Docket
47-8743

June 15, 1981

Re: Hydro-Engineering Materials Relating to Correction of Figures 5.7
and 5.9 of the Sand Rock Mill ER - NRC Docket No. 40-8743

CALCULATION SHEET FOR SEEPAGE

FIGURE 5.9

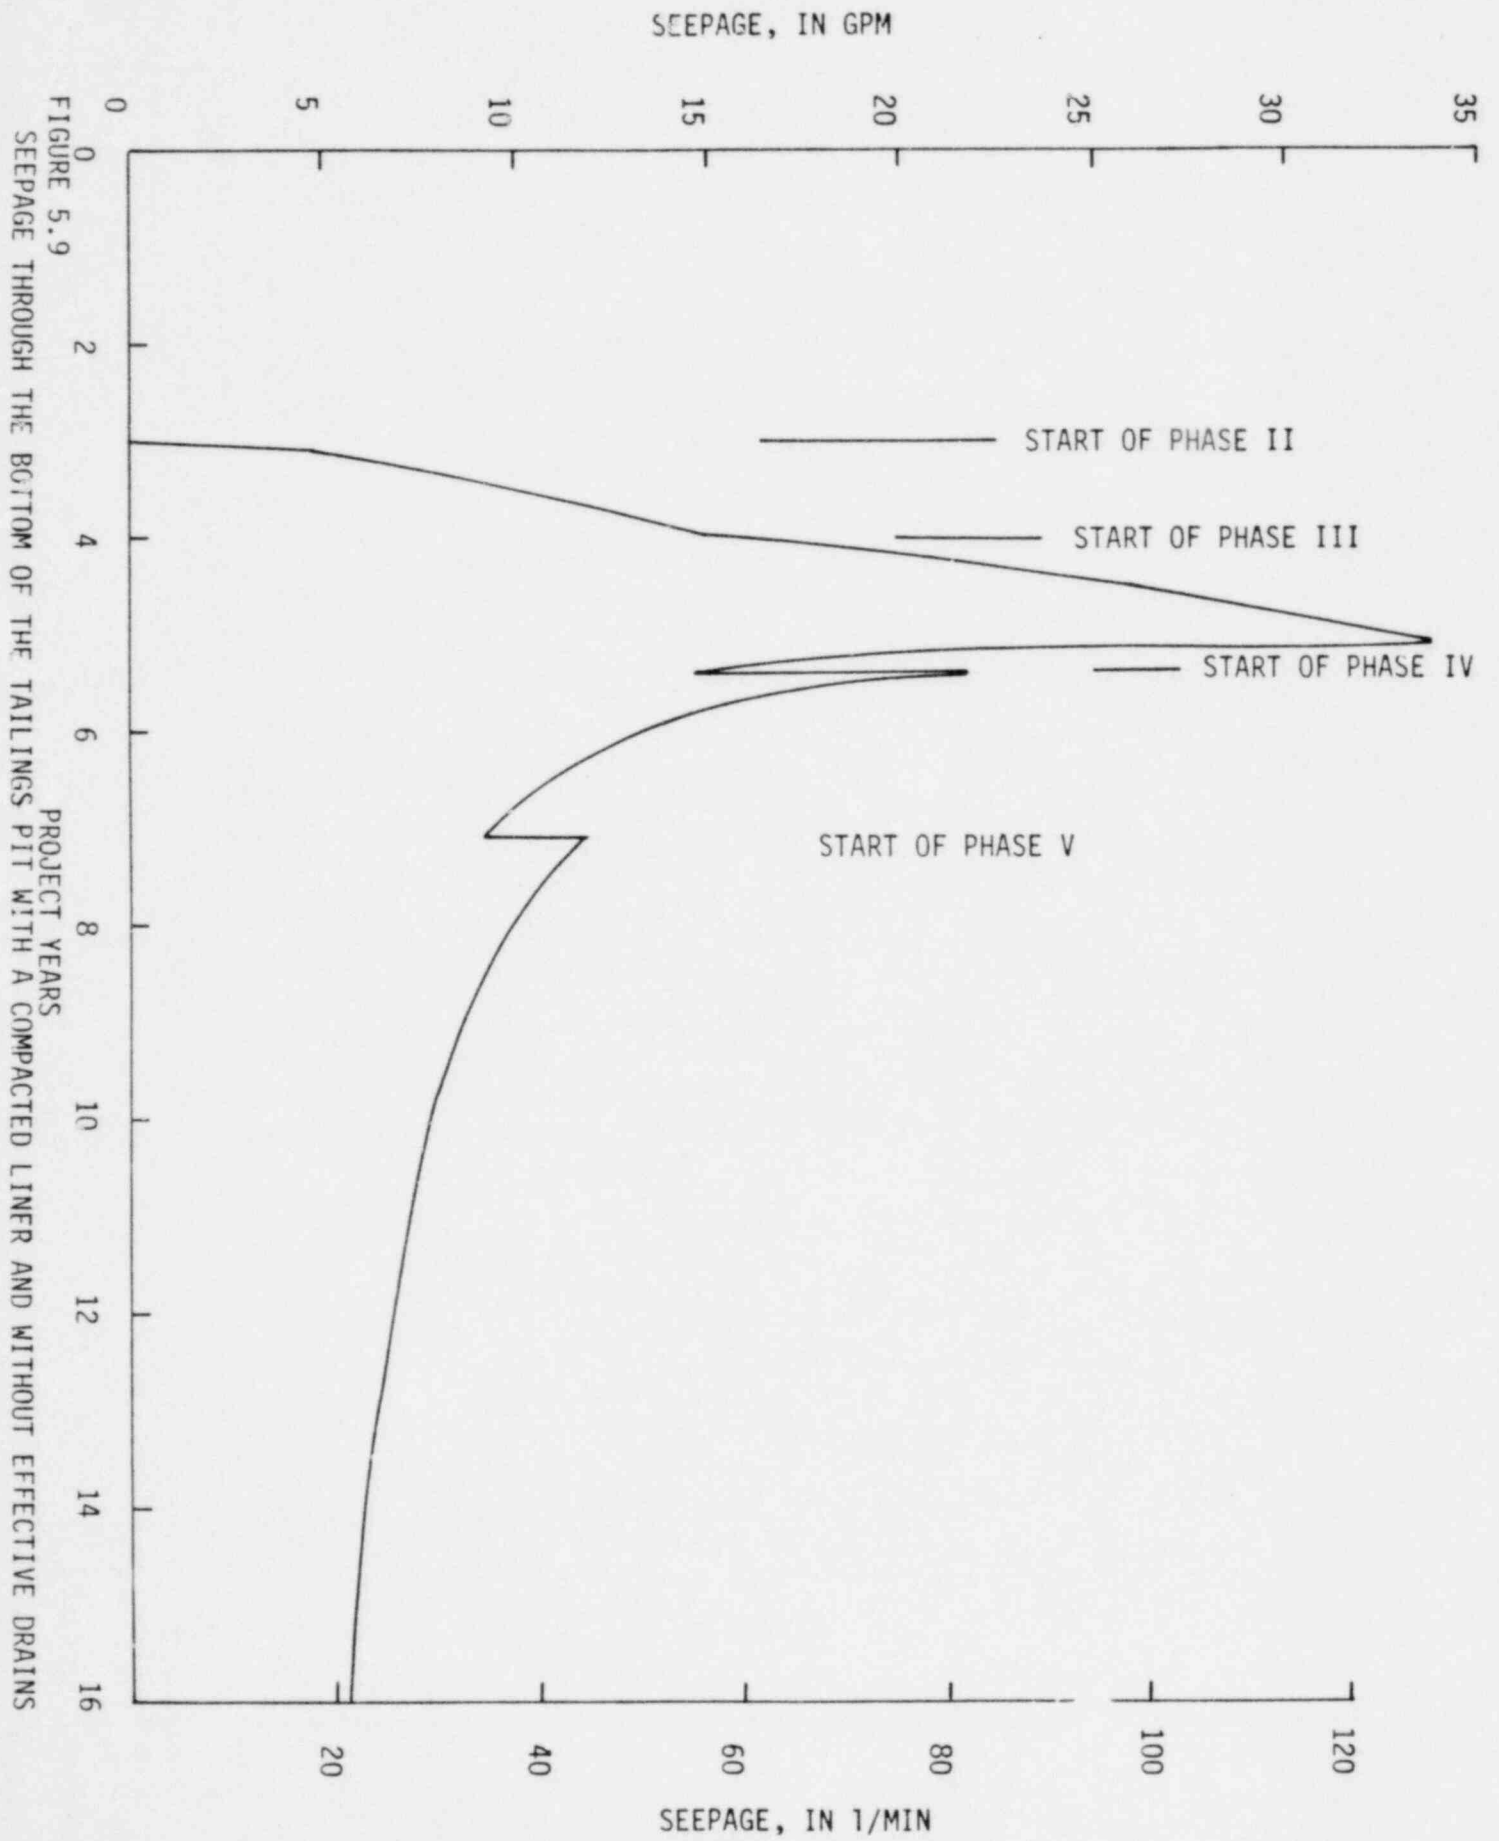
The enclosed calculation sheet and figure present the seepage results for the 35 N tailings pit with a compacted liner and without effective drains. The original R^2 values in these calculations have been adjusted to equal area divided by π . This figure should replace Figure 5-9 of our report. The seepage rate before the start of Phase IV would be less with effective drains. Please give me a call if you have a question on this update.

CONDITIONS: SEEPAGE THROUGH THE BOTTOM OF THE PIT WITH A COMPACTED
LINER AND WITHOUT EFFECTIVE DRAINS

PARAMETERS: $Y = 0$ ft, D_t varied @ top of tailings,
 $D_s = 0.000000001$ ft, $D_l = 3$ ft, $K_t = 200$ ft/yr,
 $K_s = 0.1$ ft/yr, $K_l = 0.14$ ft/yr, $D_f = 50$ ft,
 $K_f = 10.3$ ft/yr, $n - \theta_i = 0.15$, $h_d = -10$ ft
 $\lambda = 2$ ft, $H_a = 20$ ft

AREAS WERE INCREASED AT THE ADDITION OF EACH PHASE. ESTIMATES OF SEEPAGE WITH DRAINS WOULD BE VERY SIMILAR FOR LATE TIME VALUES BUT WOULD BE CONSIDERABLY LESS FOR EARLIER ESTIMATES (ESTIMATES BEFORE THE START OF STAGE III)
